Based on feedback and years of experience doing just this sort of thing, I analyzed the available field area and surroundings with respect to field size requirements and other park amenities, discussed below. My resources are limited to googlemaps and inconsistently-scaled screenshots (i.e. this is not precise), but still much can be learned. The 2018 Parks Master Plan had a solid recommendation, but it came to an abrupt halt (below left). Many still believe there is merit in utilizing the wooded area for a portion of the dog park, but would affect trail layout. The plan I've shared (below right) is just one potential solution, based on careful thought and consideration for the various needs and stakeholders, who all deserve a welcome place in our community.

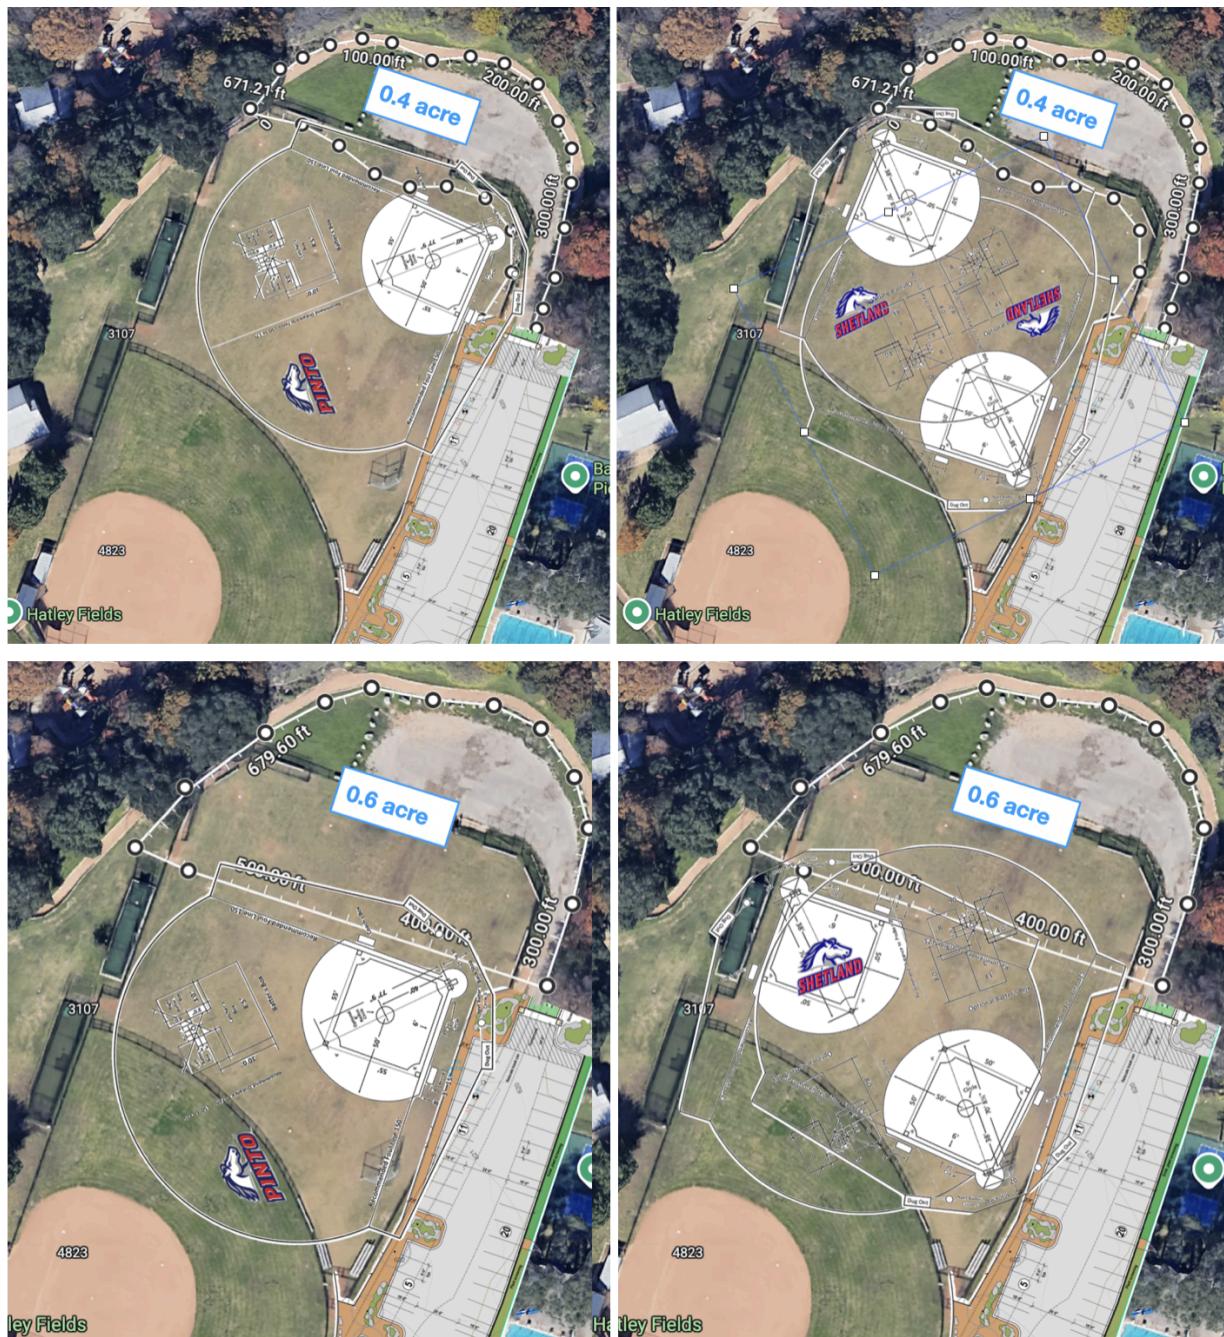
TRAIL: The trail at the north end is really nice, but could be improved with additional shade cover. You can push the trail a bit further north if you carefully remove some of the scrubby growth while still protecting the quality shrubs and trees that maintain a green backdrop and all the features that make having a trail in this area special. You'd also need a sufficient border/backdrop well away from the drop-off to avoid more unsightly fencing. I pushed the dog area into the existing trail, then widened the trail to create more of a destination - a recommendation from the landscape architect providing parking lot drawings. You can create a buffer with the dog park by using some of the existing grade change between the parking lot and trail to create a "boulder-berm" (like the work done behind the Field House), which could be a place to sit or play with cascading pollinator-friendly native plants. This could serve as a mini education garden with signage and volunteer workdays like the nearby butterfly garden. The berm has the added benefit of a sound barrier for the homes below and would need a fence on top with planted shrubs to minimize dogs at eye level with trail users. The central portion could include trees and another access gate, which also opens up a long sightline across the park from RW Dr. to the wooded crescent.

1. If we assume Fields 1 and 2 for baseball/softball are fixed, along with the proposed parking plan under review, then we have about 1.3 acres available to parcel out (top left). It might be worth debating the amount of proposed parking versus field space given that creating a double row of parking to account for the lost spots in the north lot encroaches on the shared fields. For instance, if parking was allowed on game days along RW Dr. directly in front of the park, and volunteers and/or police helped to manage road crossings - could we then reduce the amount of overall new parking?

2. The existing informal parking area at the north end of the fields is about 1/4 acre (top center).
3. **T-ball** fields need 50ft. between bases and about 115ft. min. from home plate to an outfield fence - that's 230ft. between home plates on two adjacent fields; currently there is ~165ft. between Field 3 and 5, but not every hitter is a ringer so the overlap is currently working (upper right).

4. **U8 Girls Softball** needs 55ft. between bases and about 150ft. to an outfield fence; the current distance on Field 3 from home plate to the outfield fence is ~153ft (upper right) - just at the limit for younger girls softball, but a little bit long for T-ball. Some girls are currently hitting down 3rd base into Field 5.

5. **Batting Cages** would need to be relocated (ideally close to Fields 1 and 2), and verified for size and quantity.
6. Required fields for U8 Girls' Softball "Pinto" (left) and T-ball "Shetland" (right) on 0.4 acre and 0.6 acre (below).

1. Soccer (above left): Valley View Elem. 5v5 soccer fields (standard max. 75' x 105'), allows two fields side-by-side on 0.4 acres DOLA, or soccer and another use at the same time. One rotated 5v5 field fits within 0.6 DOLA.
2. Flag Football (above right): 30 yd x 70 yd (90' x 210') on each option, with varying parking lot encroachments. The current fenced field width measures 210', so it's exactly the length of one flag football field.
